## **Peer Review of Raby Bay Geotechnical Study**

We refer to our proposal to Redland City Council (RCC) dated 29 October 2012 (Ref: 41/09157/60) in relation to an Independent Review of Proposed Works (by consultants KBR) for stabilisation of canal slopes at Raby Bay, Cleveland. This letter report presents the findings of GHD's review of the provided information and confirms the advices provided to you in telecons of 11 and 17 February 2013.

## FIGURE 1

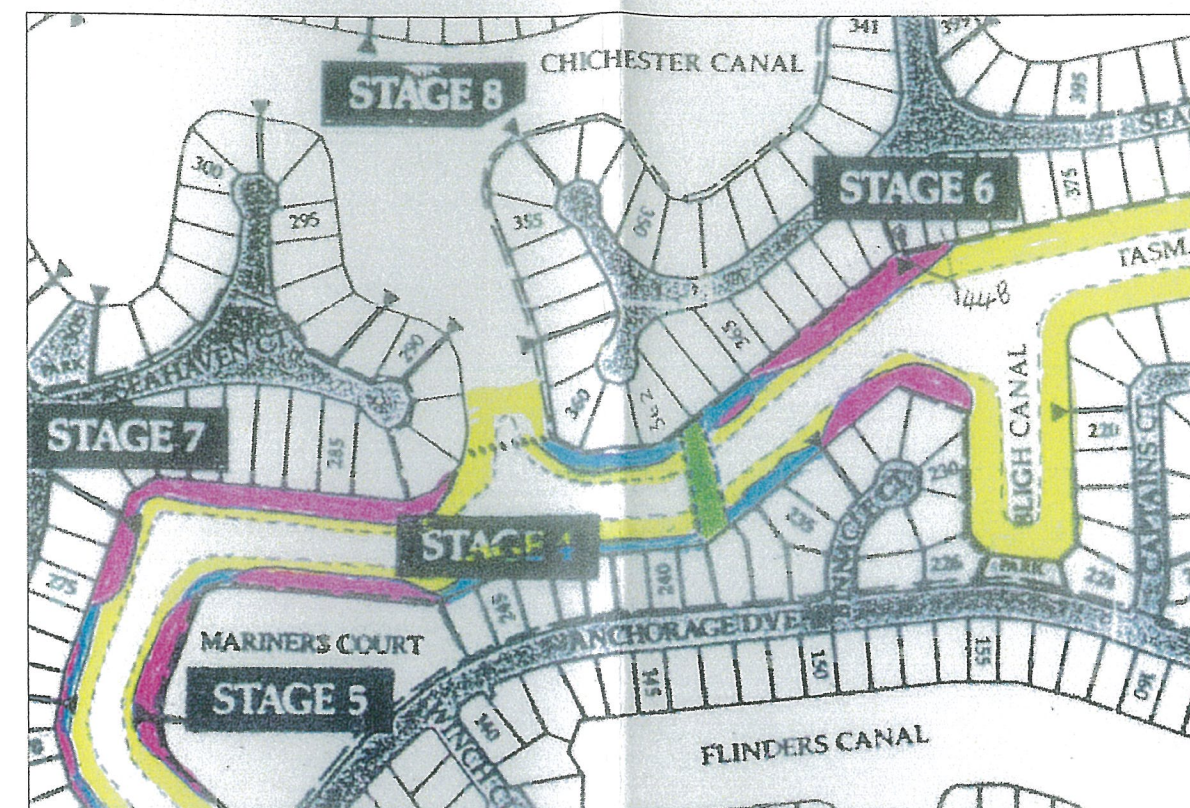
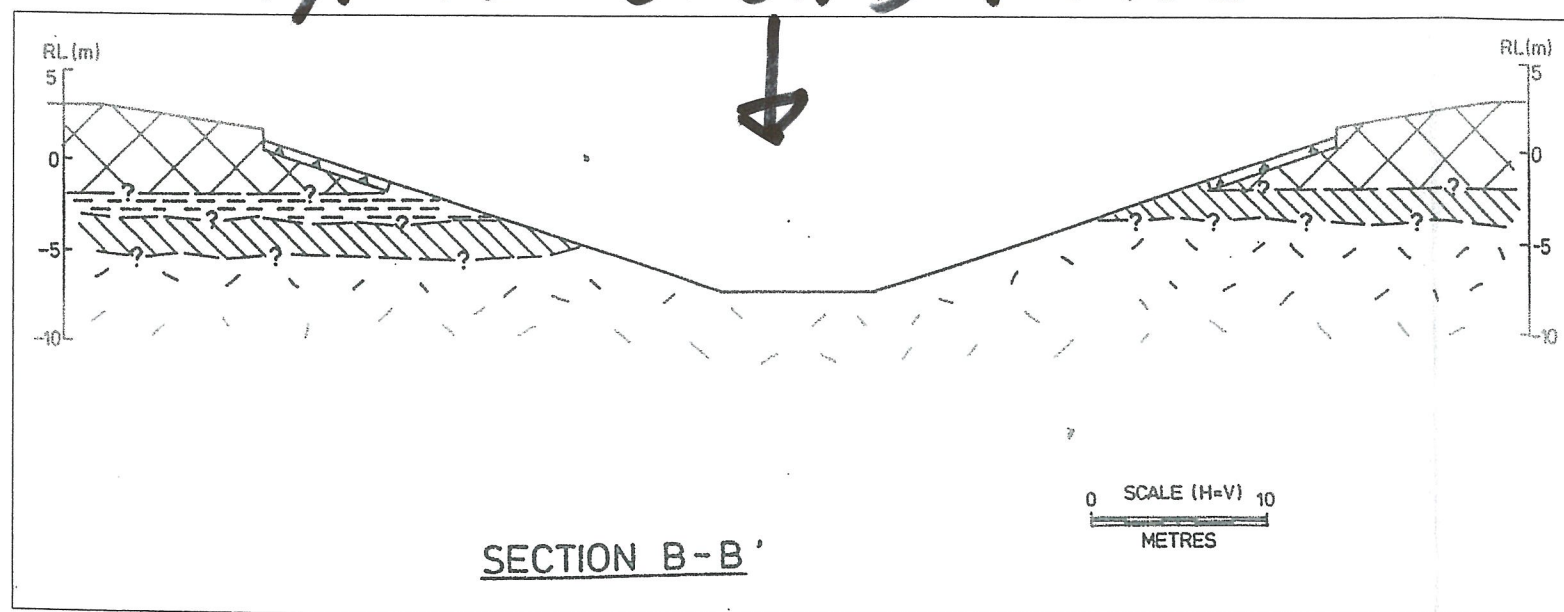
Figure 1 attached presents a simple and practical depiction of the broad subsurface profile at the development and is a useful contextual reference when considering further comments relating to ground conditions. Of course, variability (both natural and man-made) cannot be depicted in such a simplified model, and it has been noted in the literature reviewed that variability can be extreme and over very short distances.

Figure 2 Explanation for Slip-Related Movement Directions

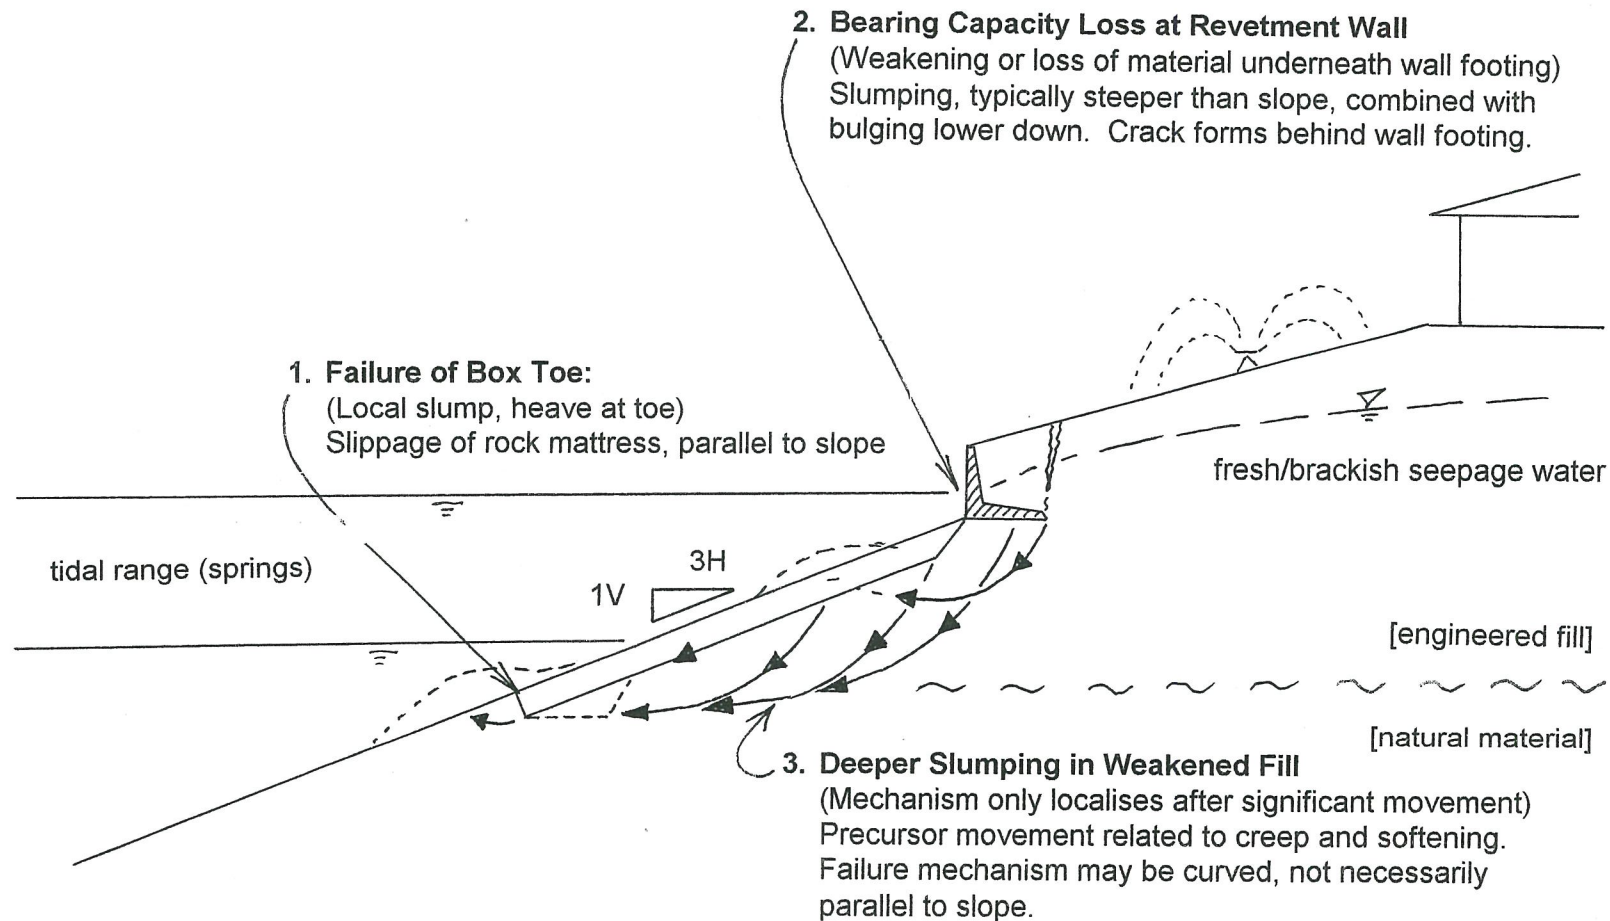
- In 1998/99 SGRS were engaged for several tasks and advised that fissured clay had only been a cause of short term failure during construction, areas where there may still have been some remnant insitu fissured clay were not considered to be at risk of future instability, all fissured clay and immediate wetting-related lot fill failures had occurred and what remained was the time uncertainty of time-dependent fill failure in the lot fill ; SGRS presented sketches of types of localised failure involving the fill in the immediate vicinity of the localised splash zone rock armour (see Figure 2 attached).

**FIGURE 3**

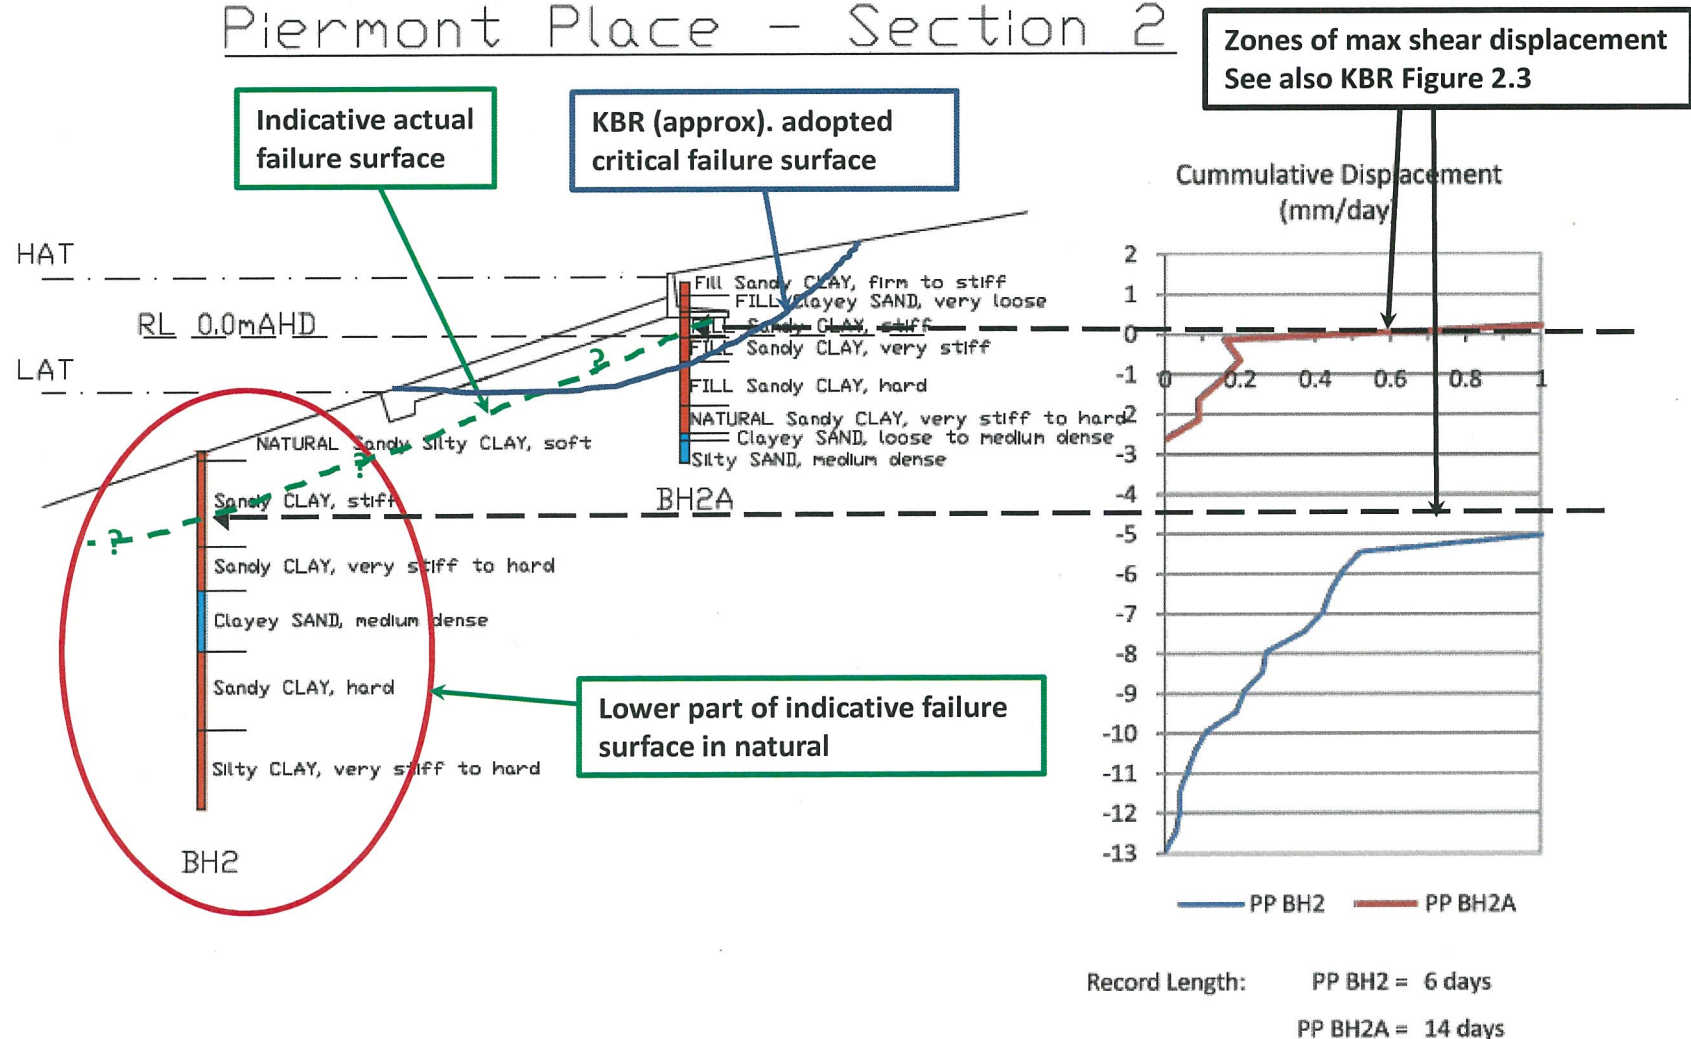
In this context, it is pertinent to consider the inclinometer data and subsurface profile prepared (and relied on more broadly) by KBR for Piermont Place – Section 2 from their 2012 report. The section has been annotated by GHD and this version is presented in Figure 3 attached. GHD considers this the most useful and reliable inclinometer data reviewed as it was located in a known moving mass and there are consistent movement trends identified. This clearly indicates a translational slide developing with movements occurring at depth in natural stiff clayey materials (not only in fill as postulated by KBR) well downslope of the toe of the rock armour. This contrasts with KBR's view that all movements are largely in fill and exiting at/near the toe of the rock armour. The location of greatest movement at around RL-4.5 is

consistent with the understood construction practice i.e. foundation preparation for placement of fill would not have extended to this depth according to the design and hence insitu material forms much of the bank as a cut face profile.

For the failure at Piermont Place to have occurred, the only reasonable conclusion from the material reviewed is that natural material with a low strength likely caused by fissuring and/or softening existed at some depth and combined with many other factors, was the main contributor to the collapse. Lot # 843 is across the canal from where GHD understand this failure occurred, and from the available information likely suffered a similar fate.

The 2012 KBR report does not address this mode of failure and neither do the stabilisation measures proposed. GHD considers this a notable omission.
